## Hotwheels™ Pinball GI Epic 3 Wiring update

With the new software update set to release on the week of the 6/29/2020 the location of the wire that drives GI EPIC 3 on the right side of the playfield needs to be replaced as per the instructions below.

Figure 1: Hotwheels Playfield Bottom

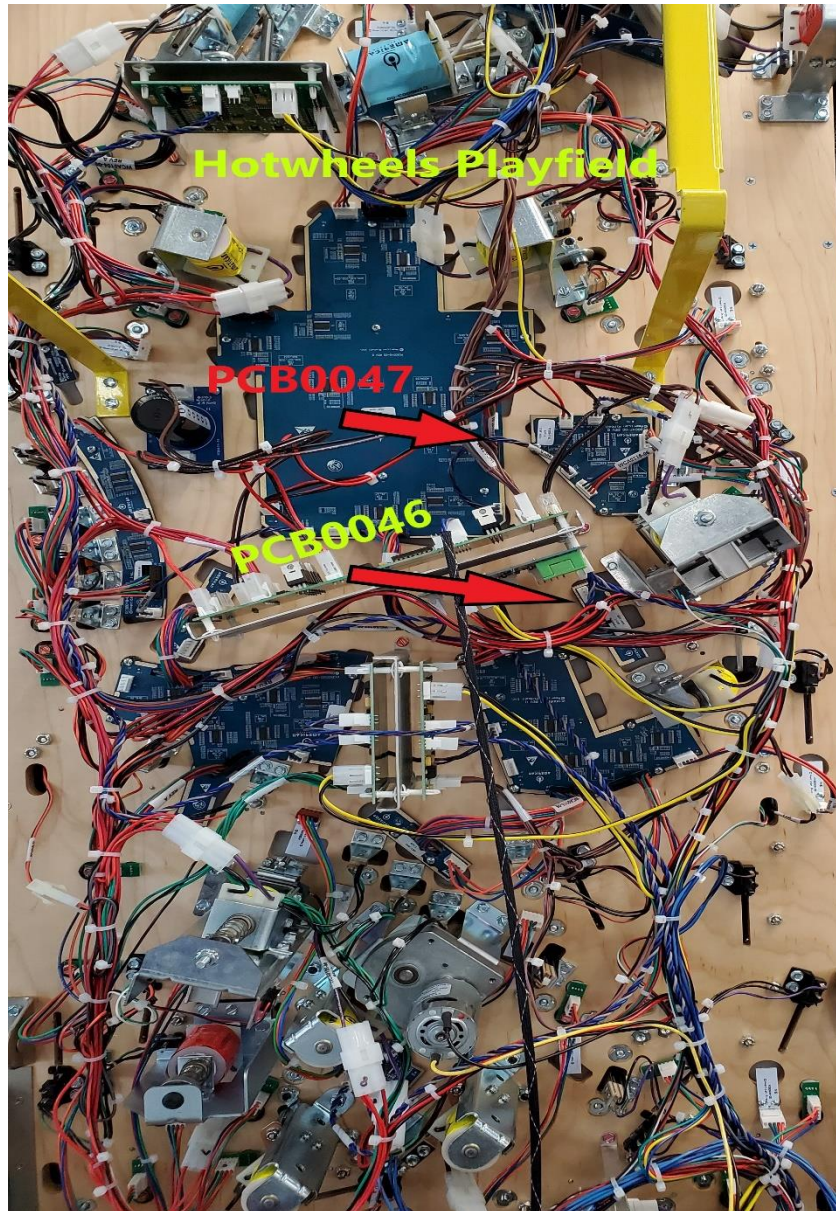
- 1) After turning off the Mains power to the pinball machine Open the playfield glass and place it on a secure area.
- 2) Lift the playfield up and locate the PCB0047 and PCB0046 as per the below picture.

Figure 2: New connection location

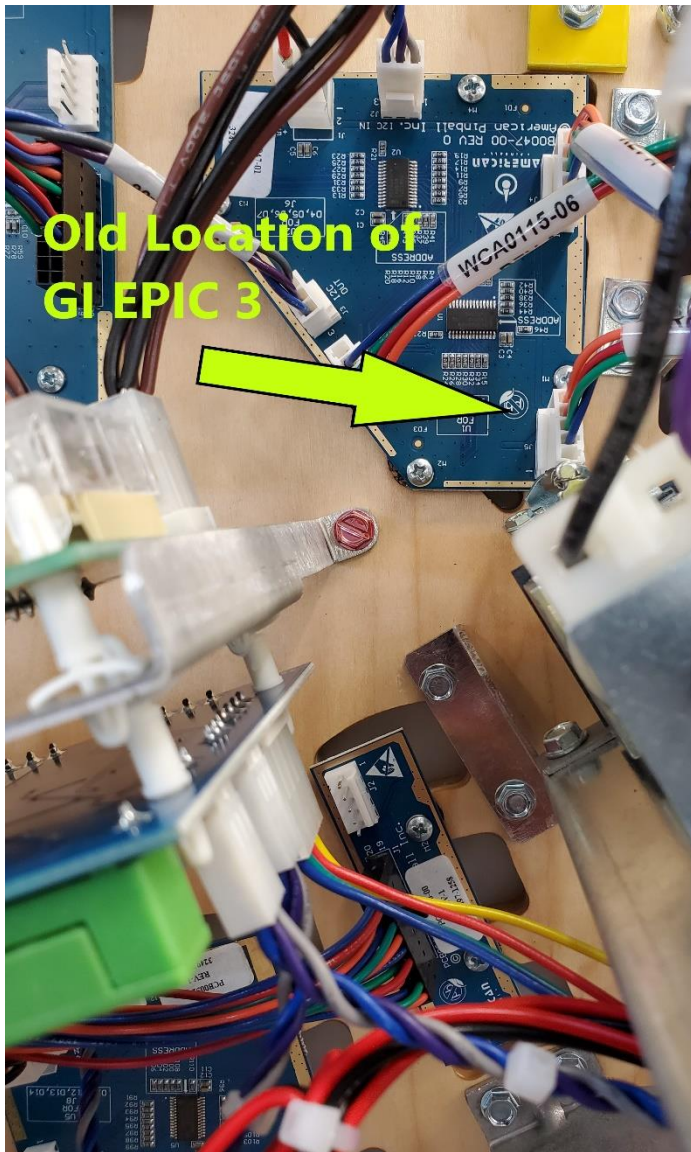
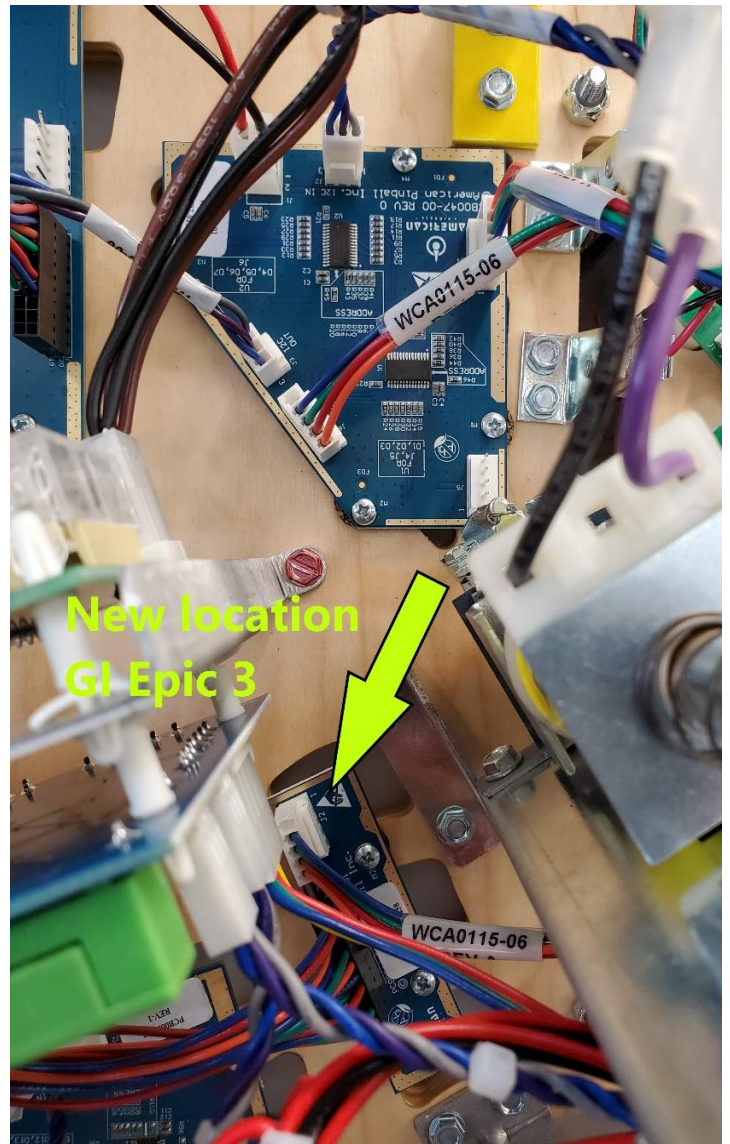
- 3) Take off the connector from the old position on PCB0047 on connector J5 as shown in the picture and replace it to the PCB0046 connector J2.

Figure 4: Assembly screw locations

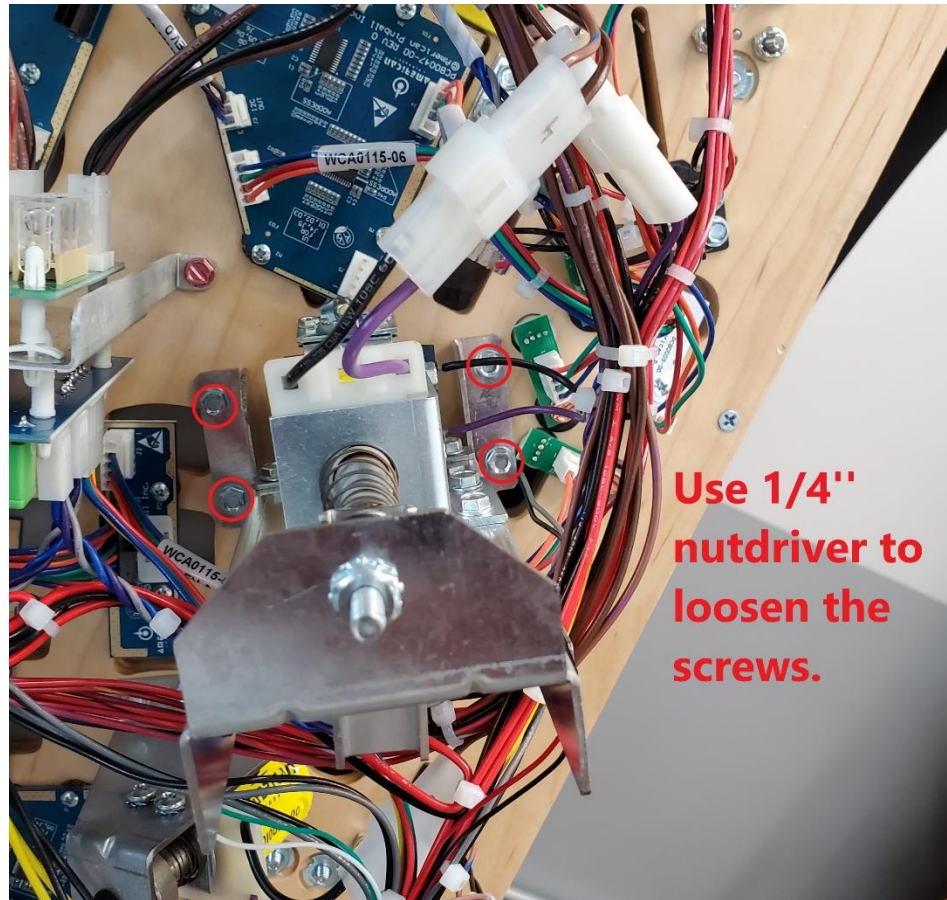
- 4) During this process of wiring change if the drop target assembly is in the way and if there is not enough room to pull the connection off then you can loosen up the assembly using  $\frac{1}{4}$ " nut driver and it will give enough room to disconnect the wires.
